# Service Bulletin

S.B. No: 84

**Title:** INSPECTION OF RIB 2 LOWER FLANGE BOND TO WING SKIN

FIG 1  
 LOWER SURFACE PORT WING  
 STBD SIMILAR

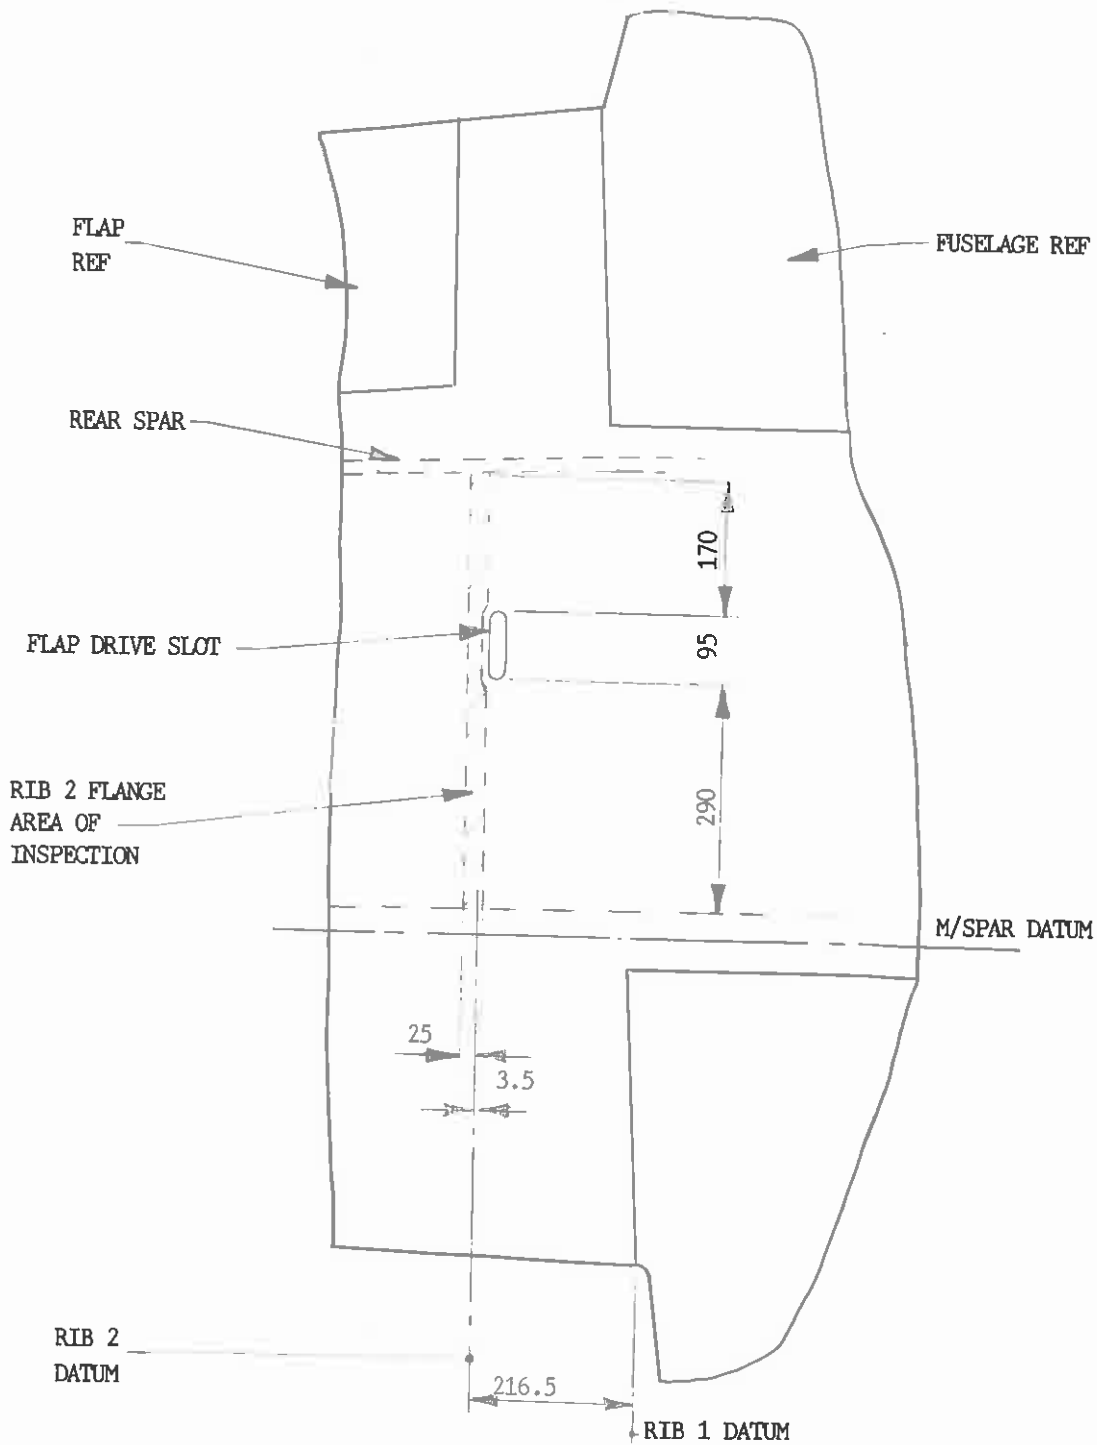
1. Referring to Figure 1, determine integrity of bond over area indicated, by applying tap test and listen for tonal changes which indicate voids. (This should only be carried out by persons with composite bonding experience). Record area of de-bond.
2. If area of the void is determined to be greater than previously recorded, Mod M678 is to be invoked ref para 4.
3. If bond is found to be satisfactory, ie no greater than previously recorded, annotate in Logbook "SB 84 complied with this Annual Inspection". Repeat paras 1, 2 and 3 at next Annual Inspection.
4. If the bonded area has grown, inform SAL Product Support Department quoting Works/Construction/Serial Number of affected aircraft. Rectify in accordance with Repair Drawing T67G-03-049 (Mod M678) before further flight.
5. On completion of repair, annotate logbook "Mod M678 incorporated".

For Repair Drawing T67G-03-049 "Repair to Rib 2 Flange to Lower Skin Bond" contact SAL Product Support Department.
